A submission to Project Application 08_0194 – Kings Forest.

It is my submission that, for reasons set out below, this application is not fit for approval, and that unless amended, should be refused.

APPENDIX 1

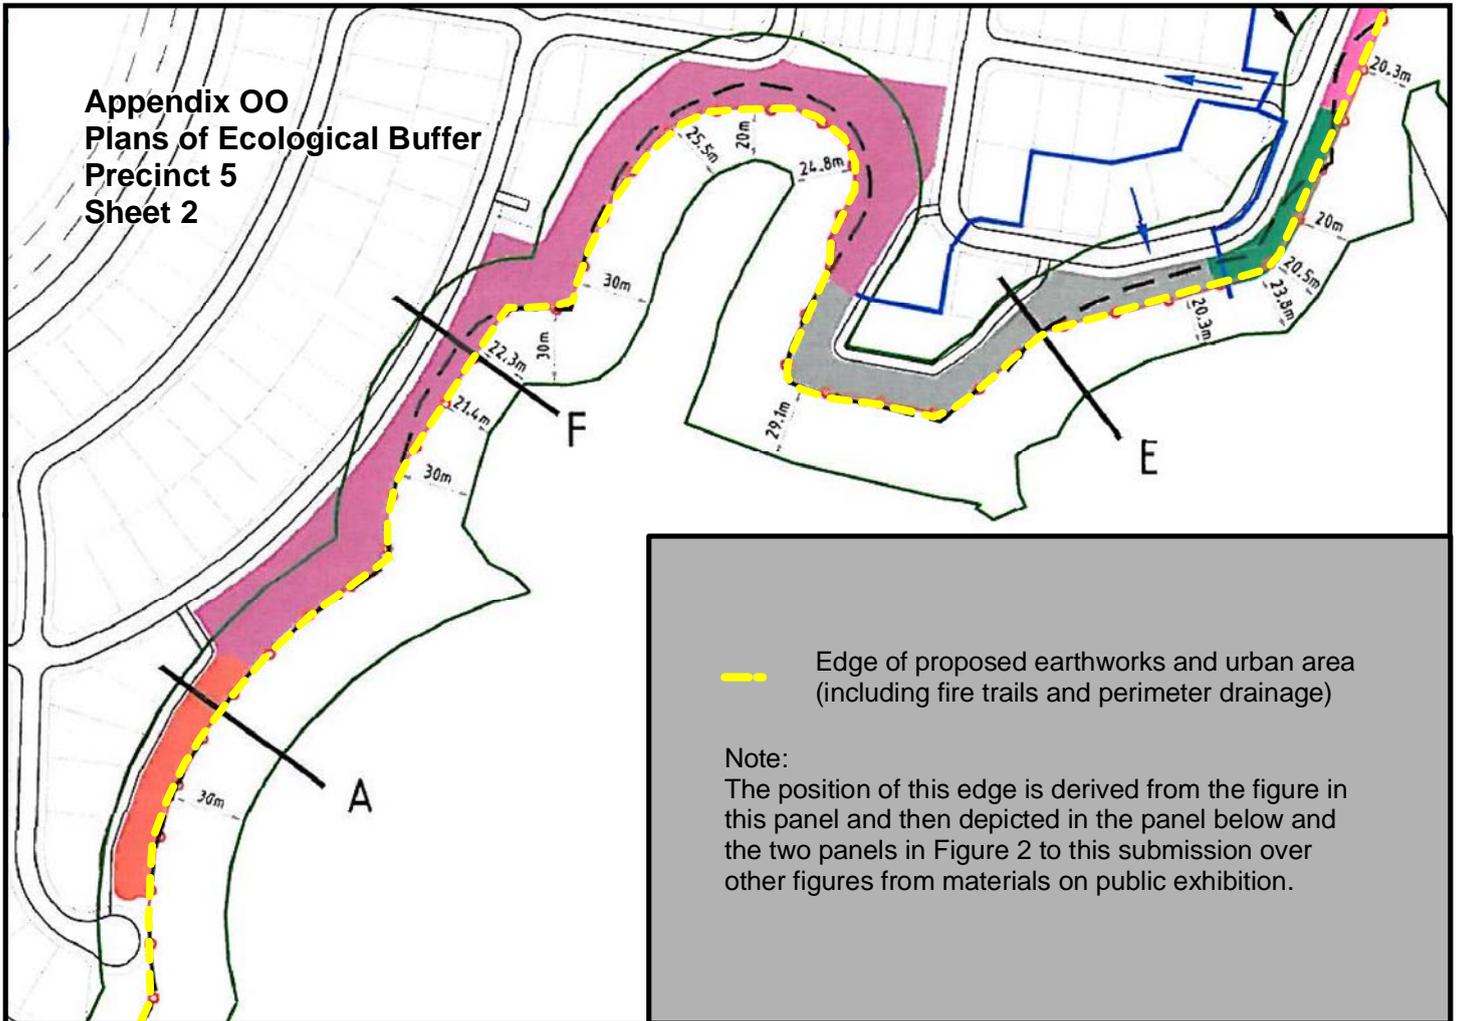
The version of the “Regeneration and Revegetation” figures in the Buffer Management Plans appears to be the product of the most recent field survey and analysis, yet at some parts of the buffers it appears to be more inconsistent with proposed development plans than earlier versions. One consequence of errors / inconsistencies in the version depicted in the Buffer Management Plan is that claims with regard to the area of proposed regeneration / revegetation of heath in precinct 5 should not be accepted

See figures 1 and 2 to this submission (Appendix 1) which depict part of the buffer in precinct 5.
